UNITED STATES
NUCLEAR REGULATORY COMMISSION
WASHINGTON, D. C. 20555

March 28, 1986

Docket No. 50-267

SUBJECT: SUMMARY OF MEETING WITH PUBLIC SERVICE COMPANY OF
COLORADO (PSC) TO DISCUSS FORT ST. VRAIN (FSV) TECHNICAL
SPECIFICATIONS (TS) - LCO 4.1.9 ON MARCH 13, 1986

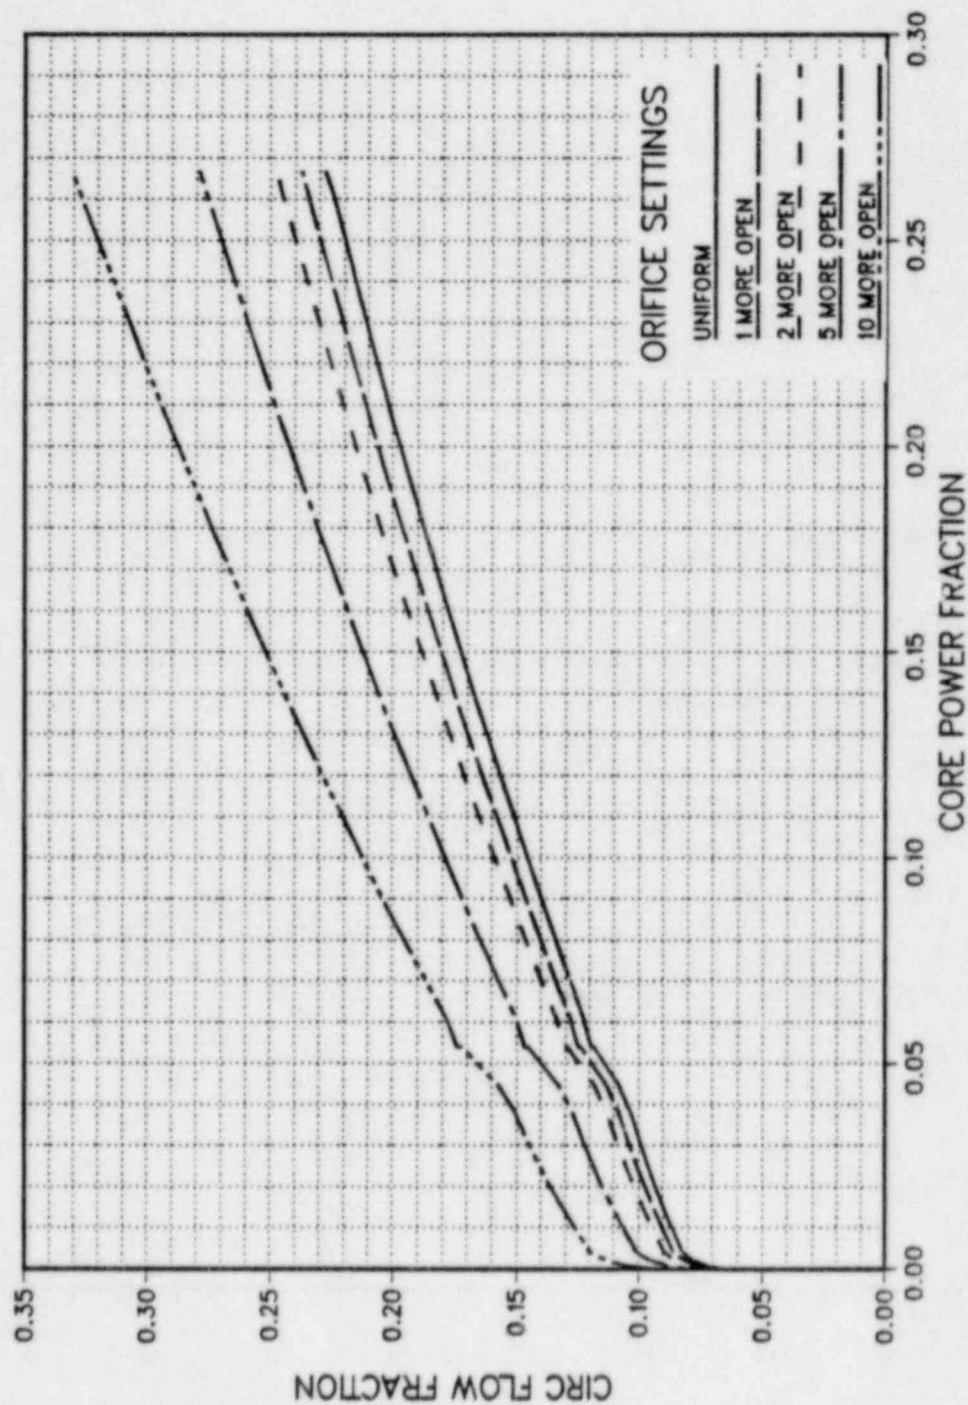
Comment 4 - PSC will explain in the basis why the reactor is operated in the equal flow mode below about 4 percent power. Potentially, Figure 4.1.9-3 could be labeled to show the range of equal flow operation.

Comment 6 - PSC agreed to utilize an expanded scale in the range of 0 to 5 percent power, as an aid to reading the figures. The limits to the curves in Figure 4.1.9-3 would be explained.

60%-107.5% HELIUM INVENTORY ORIFICE POSITIONS OF 8%-20% OPEN

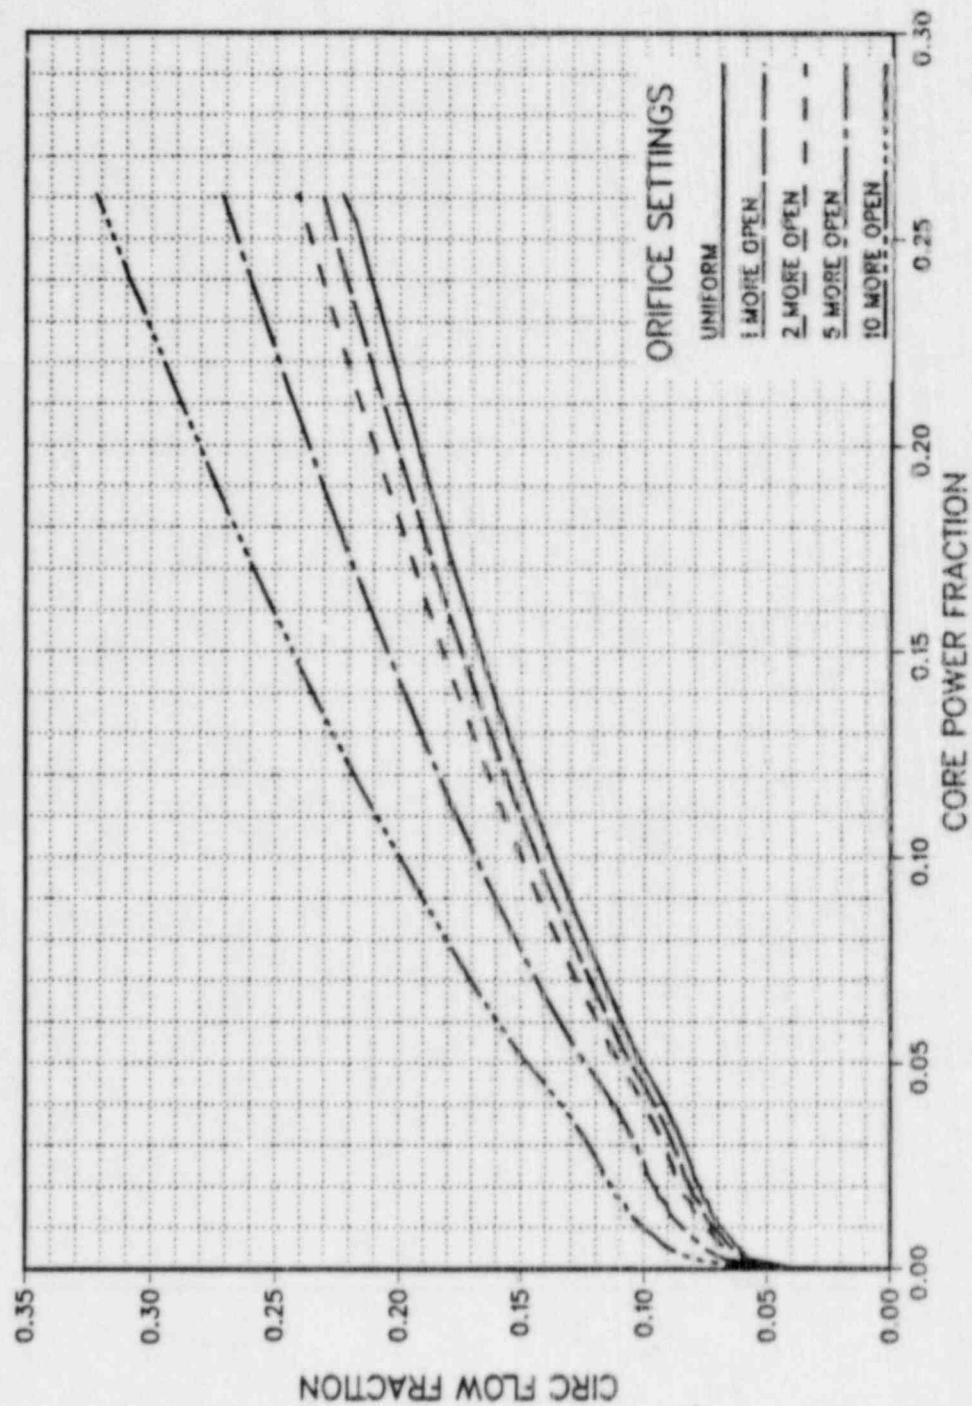
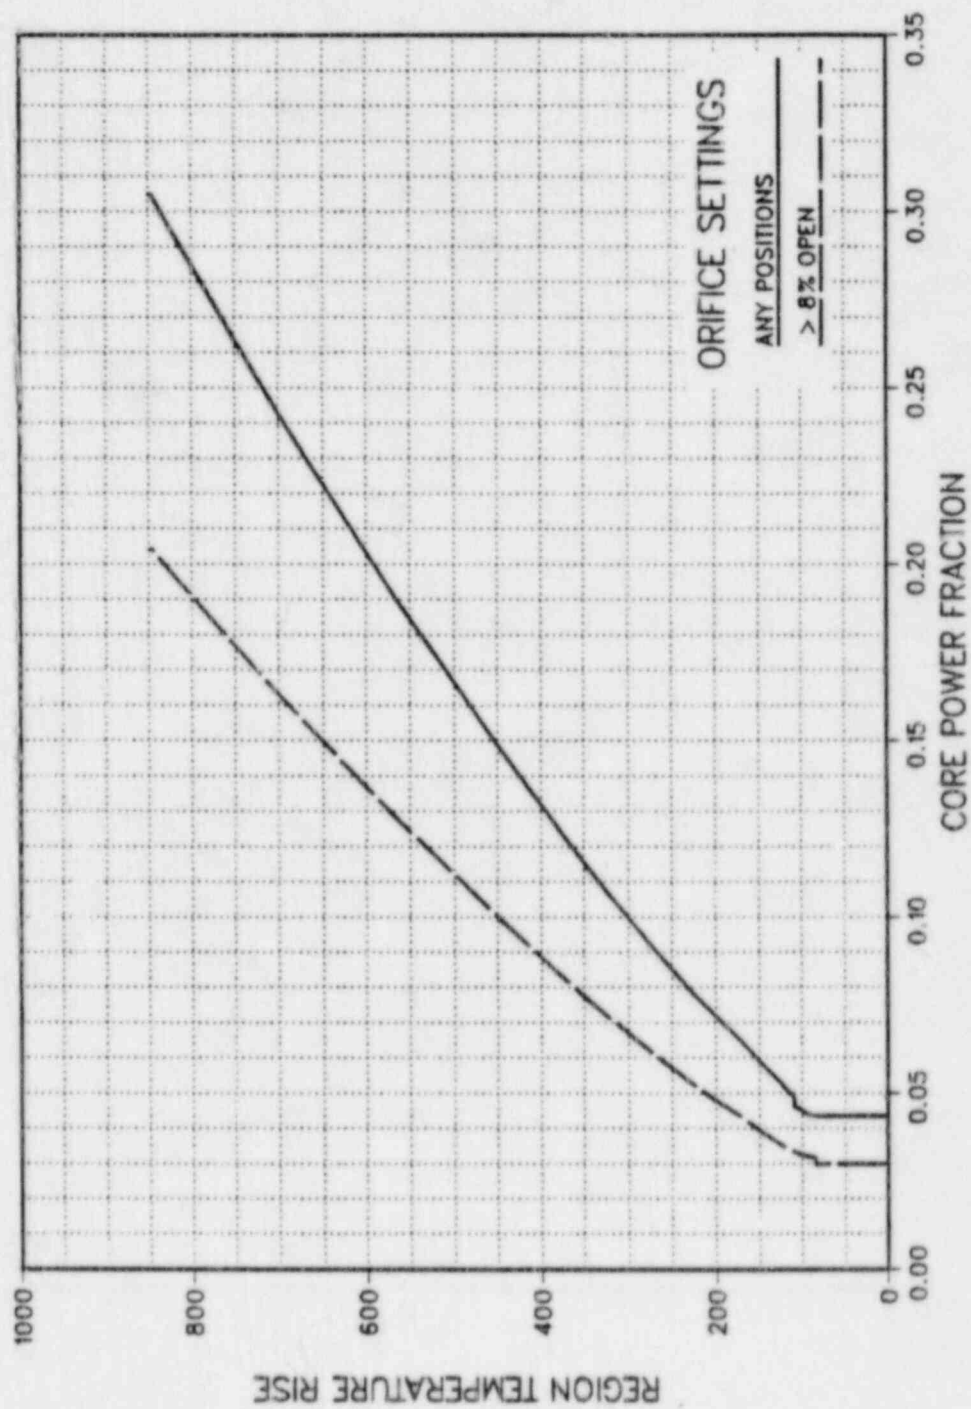
Comments 5&7 - PSC agreed to relabel the curves to clarify that they apply for a range of helium densities.
